STATE OF MAINE
DEPARTMENT OF TRANSPORTATION
16 STATE HOUSE STATION
AUGUSTA, MAINE 04333-0016

January 9, 2018
Subject: Barrel Bridge Replacement
State WIN: 018957.00
Location: York
Amendment No. 3

REMOVE SHEET NUMBER 18 OF 31, MICROPILE DETAILS ABUT. 1, and **REPLACE** with the attached, revised SHEET NUMBER 18 OF 31, MICROPILE DETAILS ABUT. 1.

PREDRILLED MICROPILE IN OVERSIZED SOCKET ELEVATION

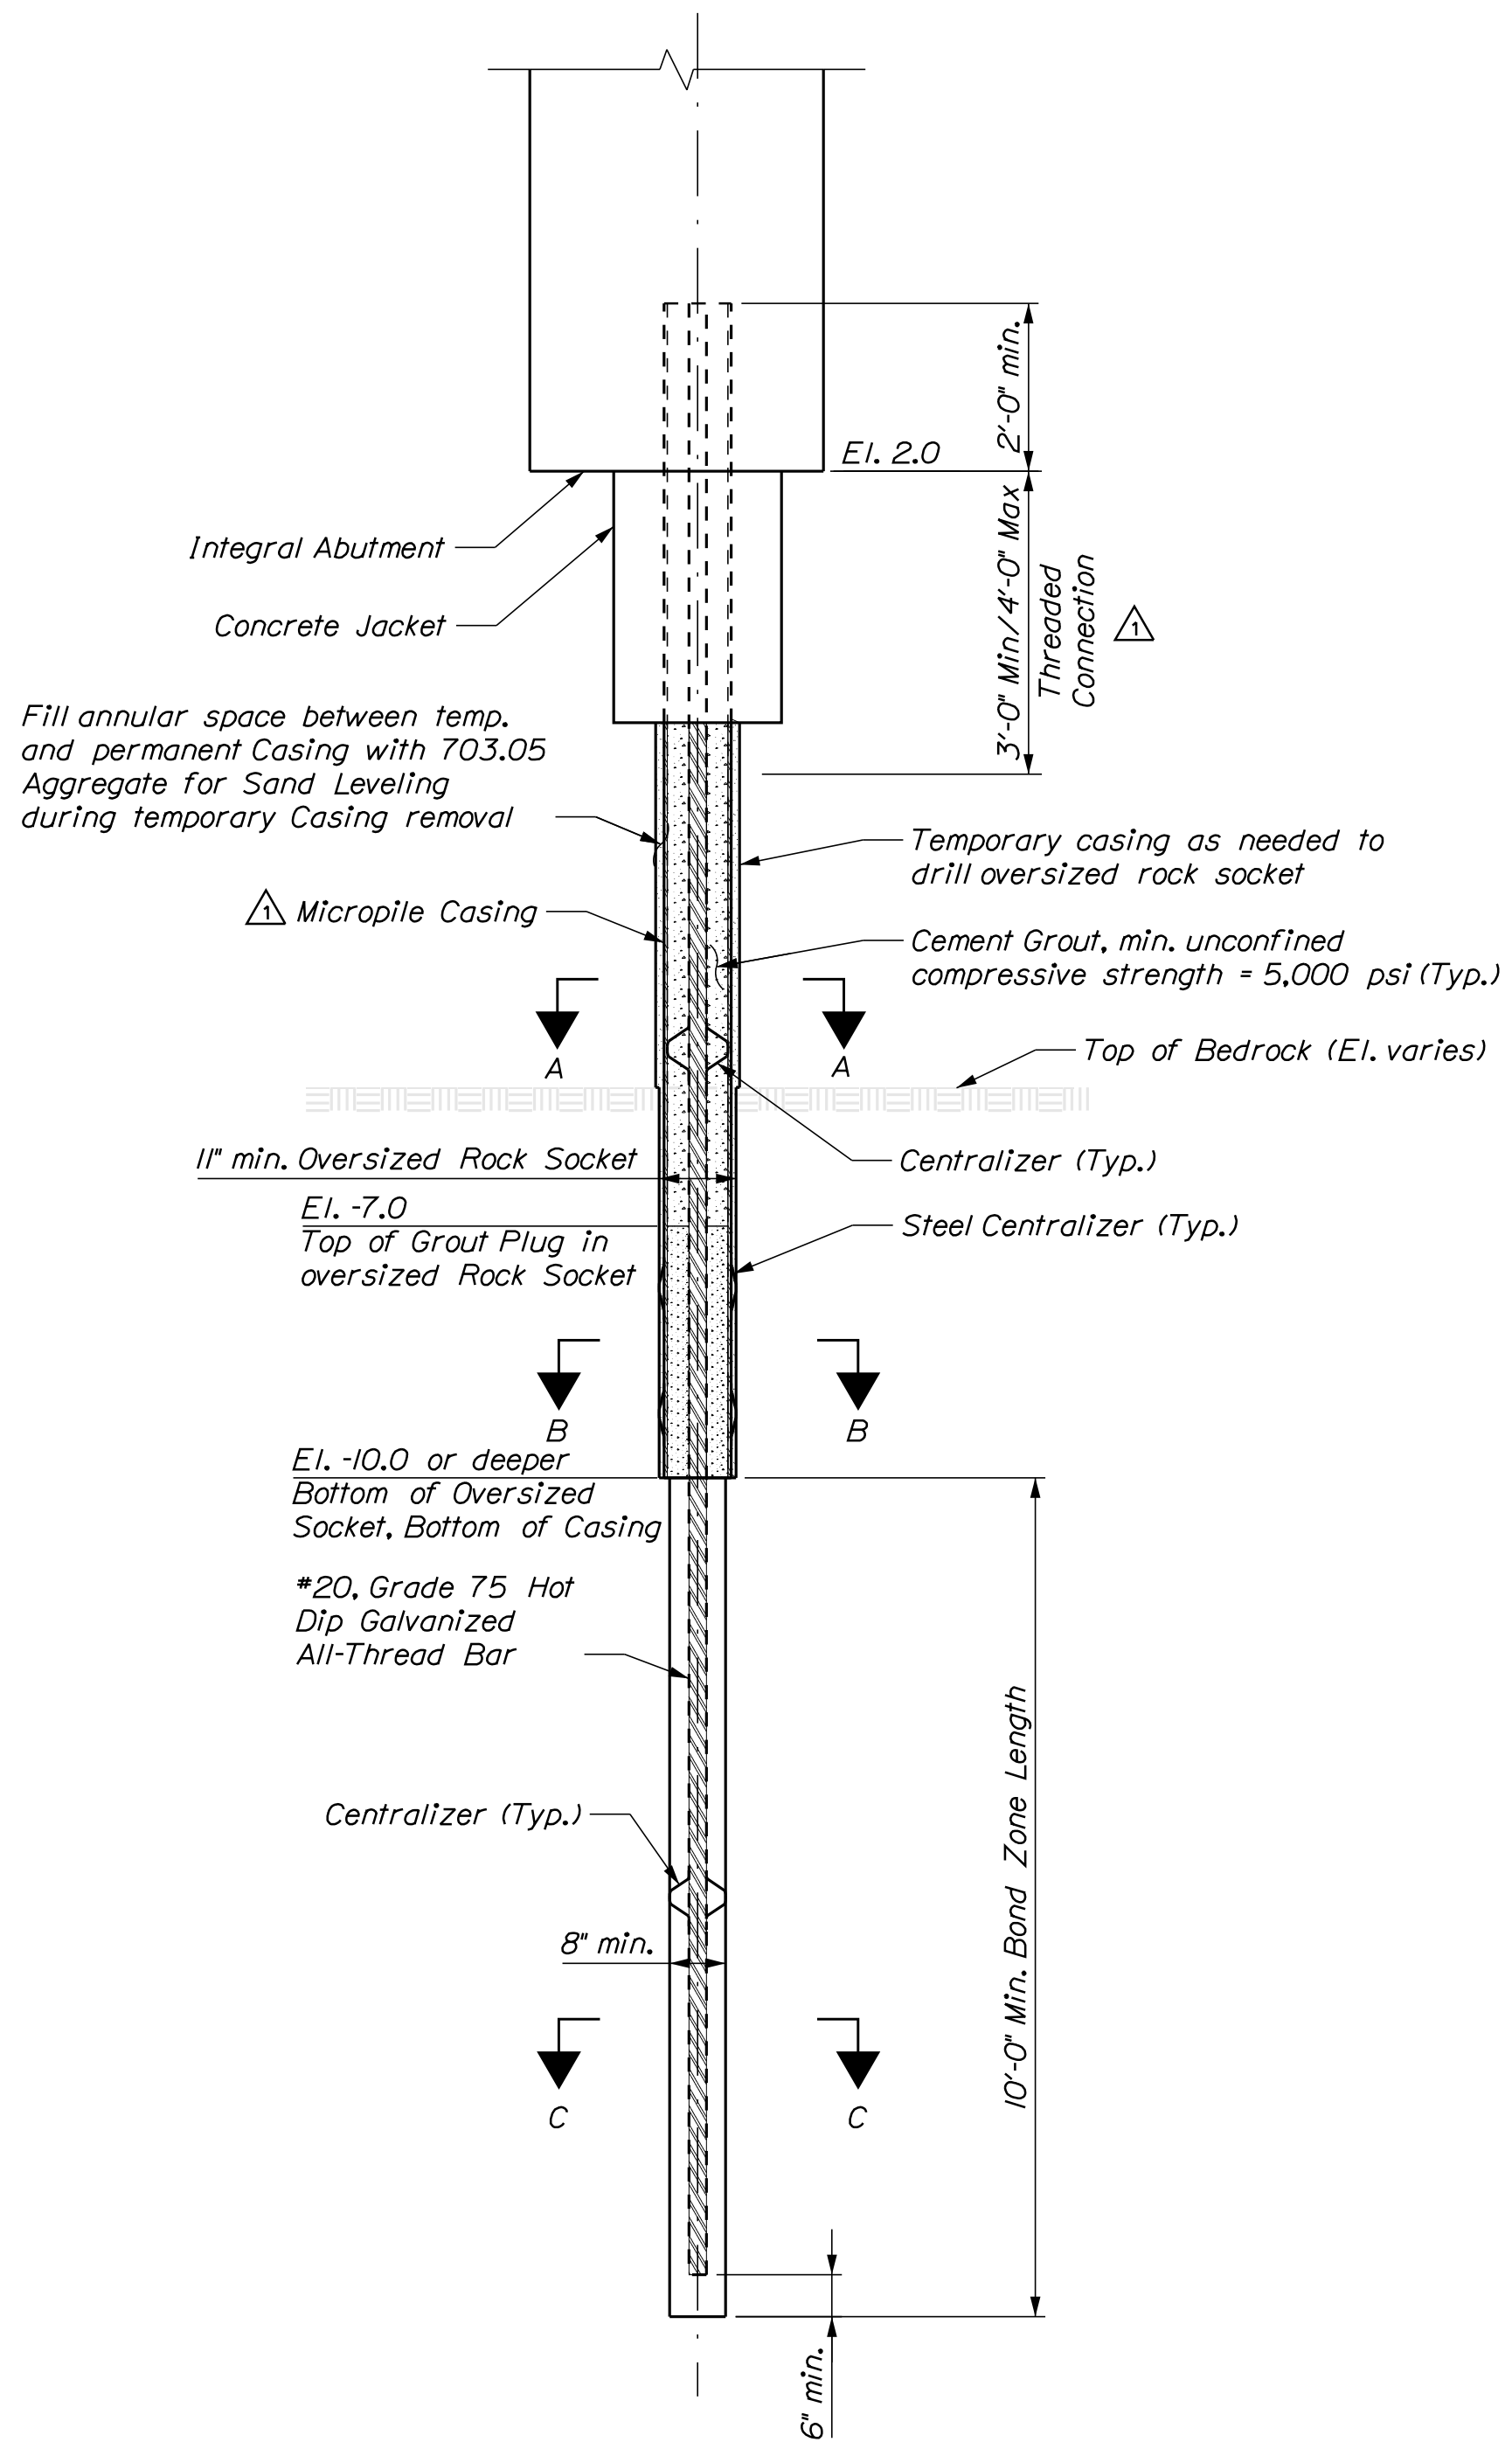
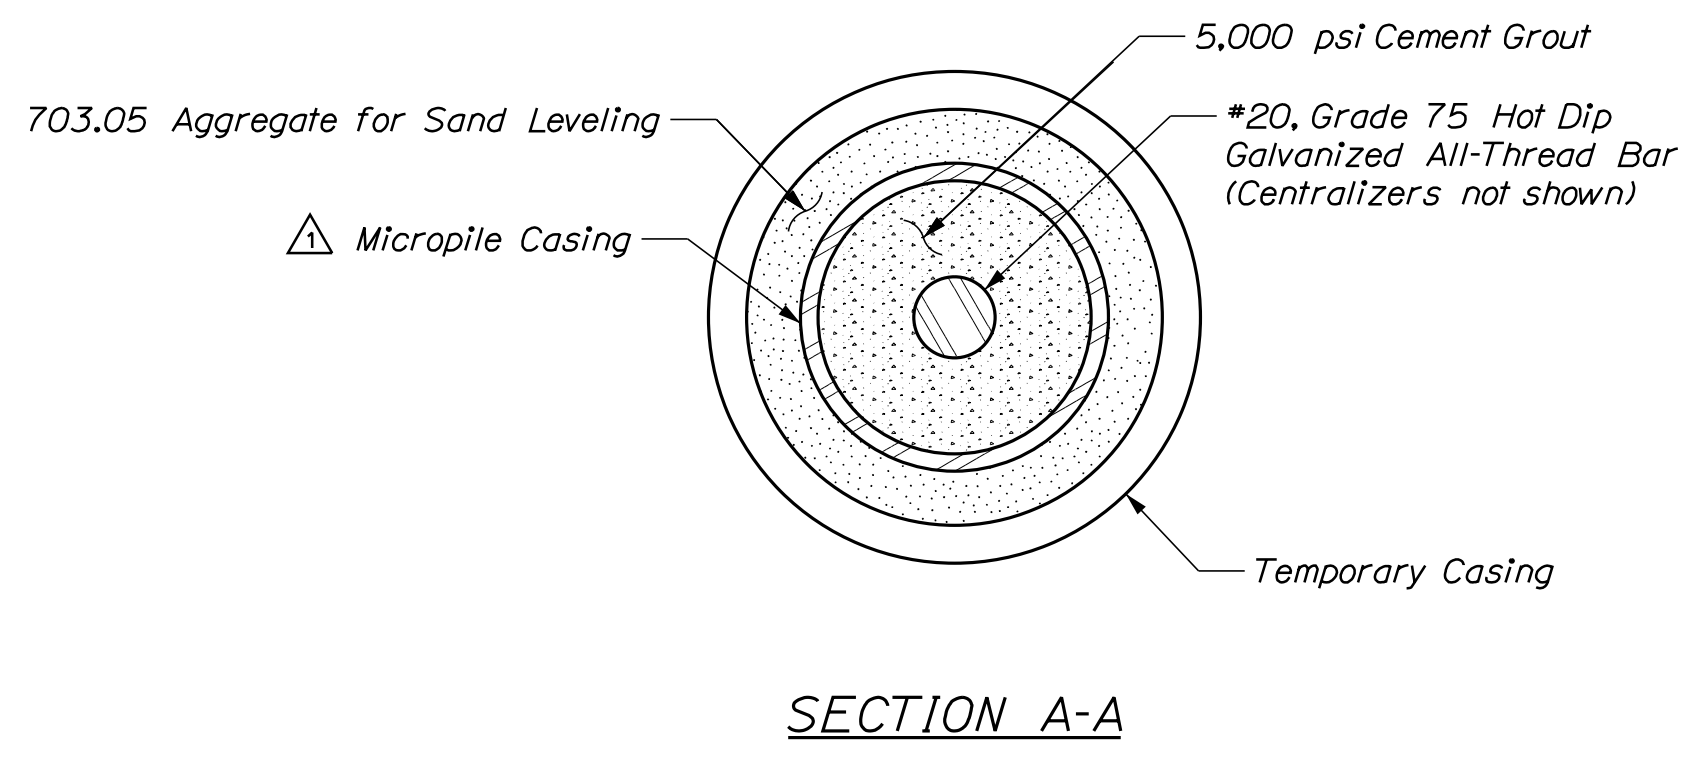
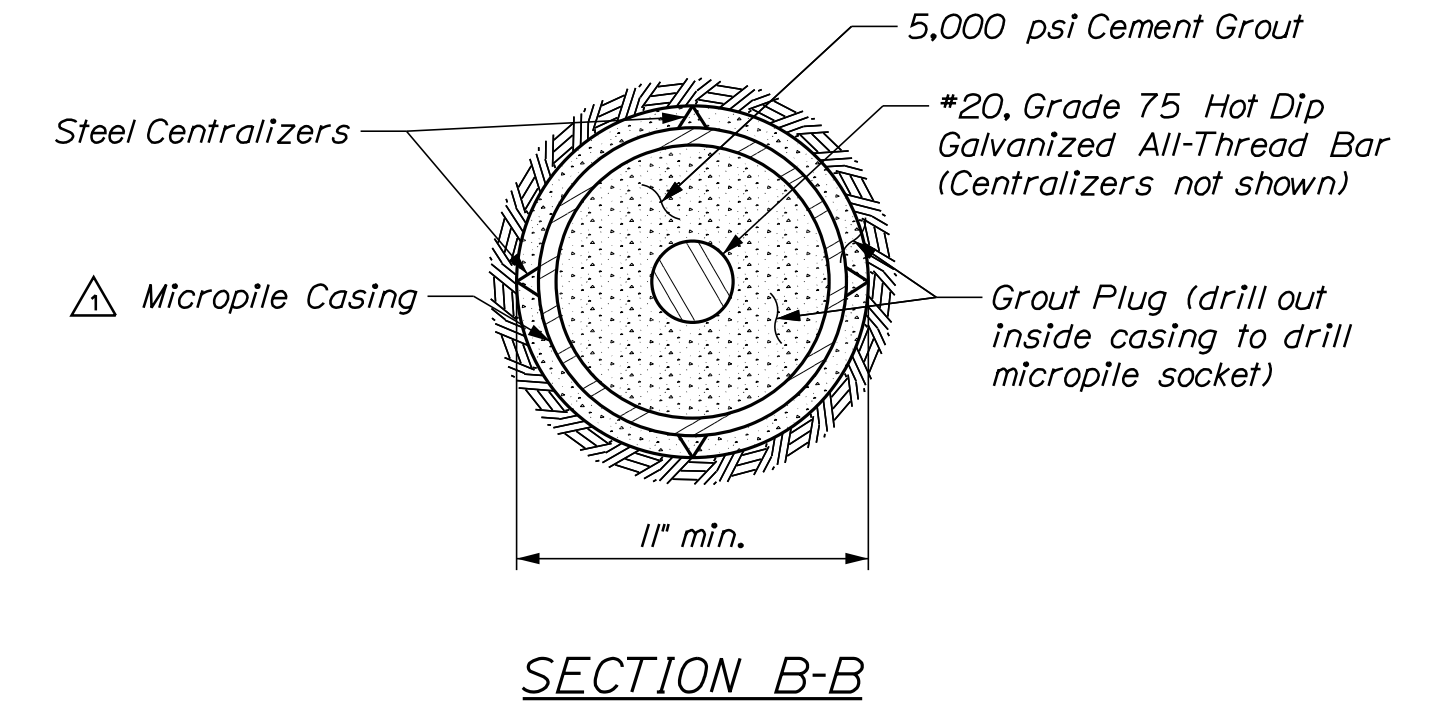
Question: Will the micropile casing need to be galvanized?

Question: Will the size of the micropile casing still be required to be 9.625" x 0.545 wall, or could a small casing be submitted?

Response: Yes, the micropile casing shall be galvanized. Please see revised Micropile Note 3, on revised Plan Sheet 18 for clarification.

Response: The micropile casing shall be 9.625"x 0.545" wall. Please see revised Micropile Note 3, on revised Plan Sheet 18 for clarification.

2. Construct micropiles in accordance with Special Provision Section 50I, Micropiles.
3. The micropile casing shall be 9.625" x 0.545" Hot Dip Galvanized, API 5CT Grade N80, Fy = 80 ksi min. or approved equal.
